NARRABRI MINE 3rd STAGE EXPANSION

SSD 10269

Objection to Narrabri Mine Stage 3 Expansion

Figure. The diagram below shows the indicative location of degassing well pads as shown in the 2015 Mod 5 Environmental Assessment (left) and a recent satellite image from 15th December 2020 (right).

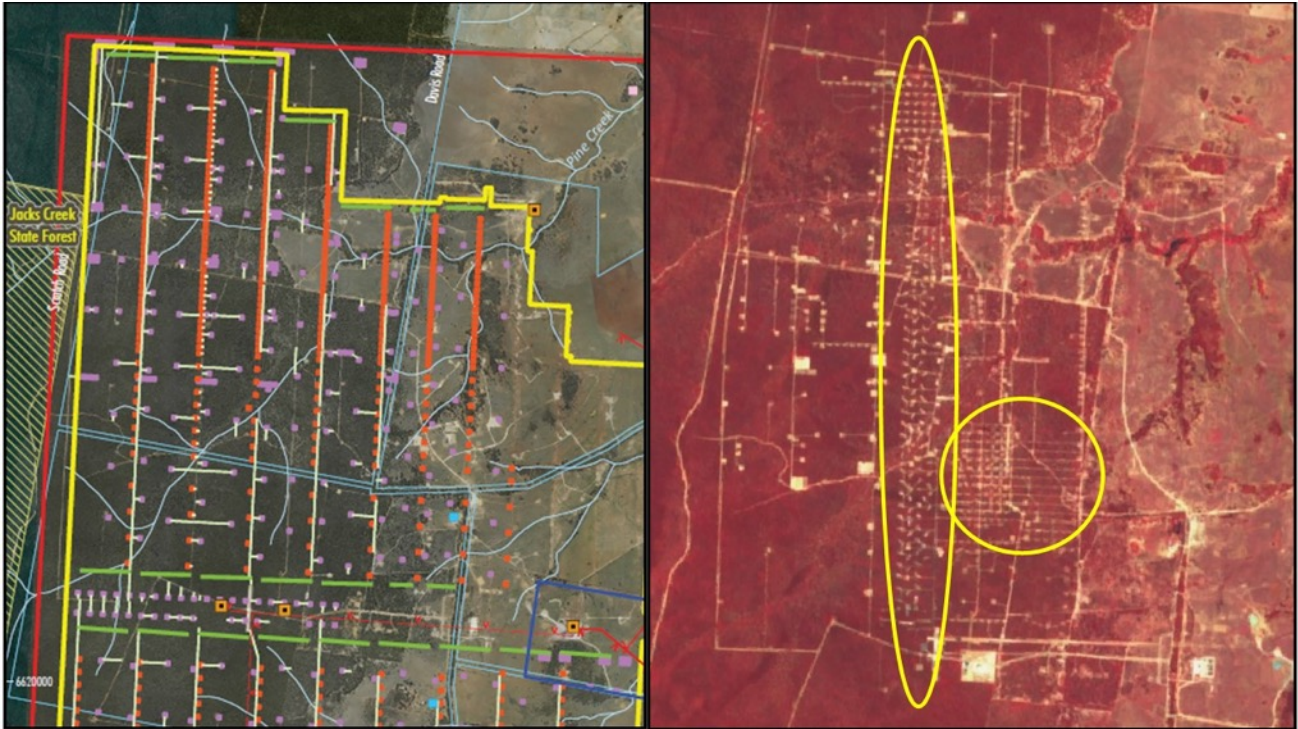
As the right-hand image shows, the number of access roads and well pads currently constructed for degassing purposes far exceeds what was indicated in the Mod 5 EA only 5 years earlier (highlighted in yellow circles), which was itself an extensive increase on what was indicated in the original 2009 stage 2 EA.
